ADDENDUM TWO, AUGUST 8, 2018

Exhibit E in original Bid Docs and as amended in Addendum 1 is updated to include the following additional information.

EXTERIOR INSULATION AT ROOF RETROFIT // 3" RIGID INSULATION		9-00800
GreenBuildingAdvisor.com © BuildingGreen LLC 2008	Scale: 1 1/2" = 1'-0"

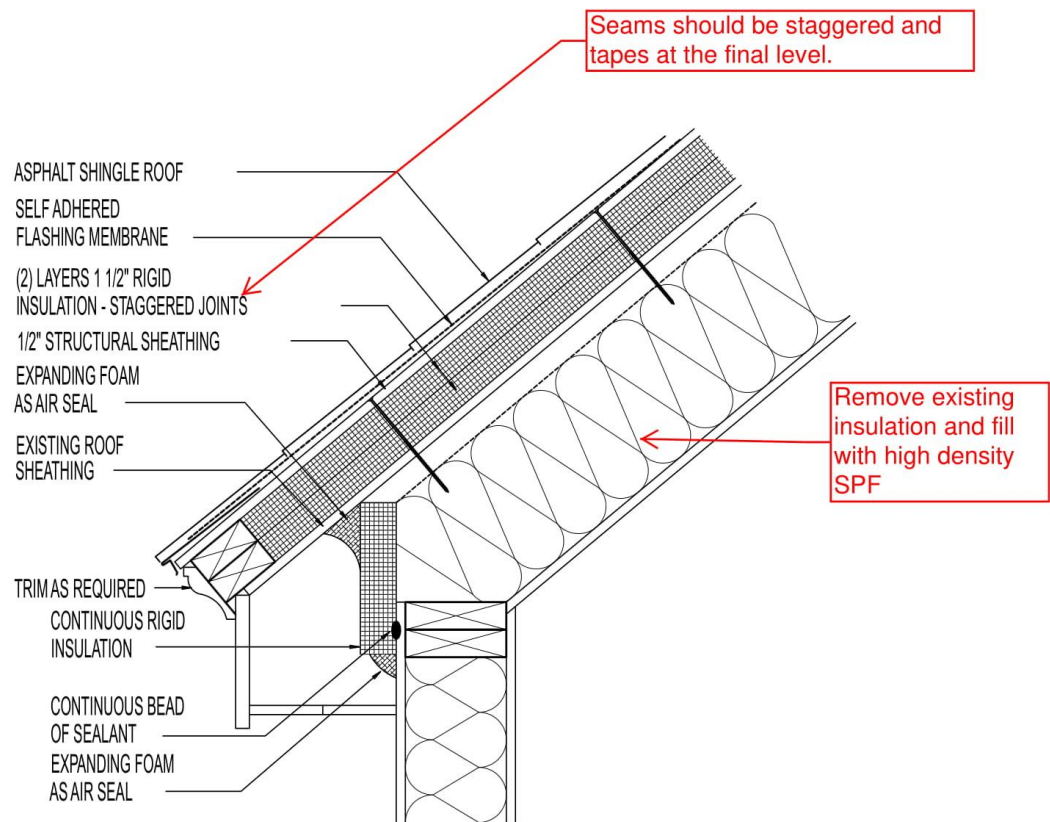
3E Thermal has provided the following supplemental guidance as to the objectives and best methods for achieving the insulation values they will expect to make roof insulation work reimbursable. The following article from Green Building Advisor provides a description and sample drawing detail (below) of the method they will require. <http://www.greenbuildingadvisor.com/cad/detail/exterior-roof-insulation-retrofit-cathedral-ceiling-rigid-foam>

As an example, assuming that the roof cavity depth is 7” (the apparent depth based upon previous work photographs) we would be able to achieve an R-42 to R-49 (depending on the manufactures rating) by filling the cavities with SPF and adding 3” of rigid foam above, adding approximately R-18 to R-22 depending on the manufacturers rating for the product(s) used.
